## RELEASE OF THE NEW XL 300 AND XL 300 DD PRINTHEADS

All XL 300 and XL 300 DD units manufactured after August 31, 1992 (Serial # 336197) contain a new style printhead with improved performance. This new printhead can be operated with the printhead adjustment (detent) lever positioned farther from the form than with the previous printhead. This provides longer printhead life, improved paper handling, and enhanced print quality on multi-part forms.

Review the following illustrations to identify the type of printhead currently in your printer:

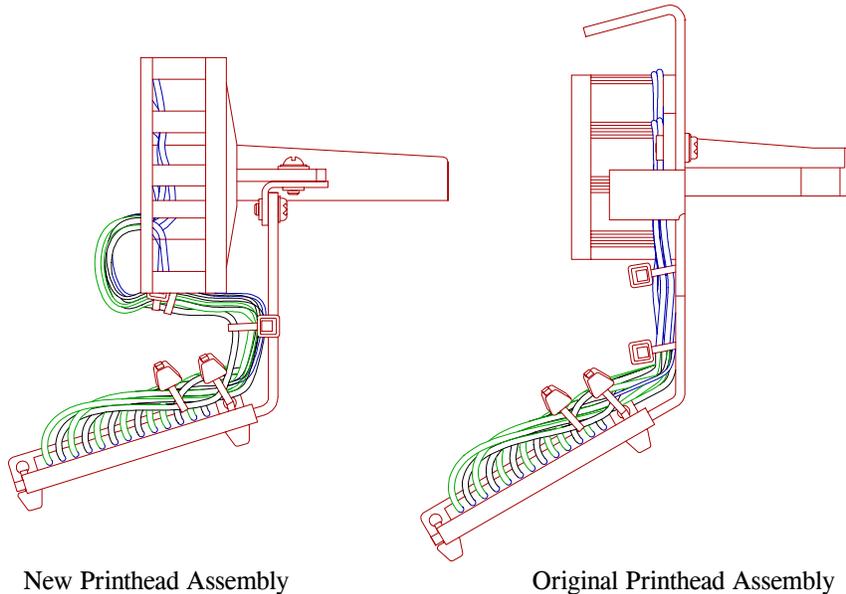
The new printheads (AAB-106057-Z XL 300 Printhead Assembly and AAB-106059-Z XL 300 DD Printhead Assembly) replace the original style printheads (AAB-105831-Z XL 300 Printhead Assembly and AAB-105832-Z XL 300 DD Printhead Assembly). The new style printheads must be used on units built after 9/1/92 and can be used on previously built units. The original printhead assembly can still be used as replacements on units prior to serial number 336197, but cannot be used to replace the new style printheads.

The installation instructions for the new printhead assembly are the same as the previous printhead. Please refer to the product maintenance manual. The platen gap specification of .012 +/- .001 measured with the printhead adjustment (detent) lever in the first position, remains the same.
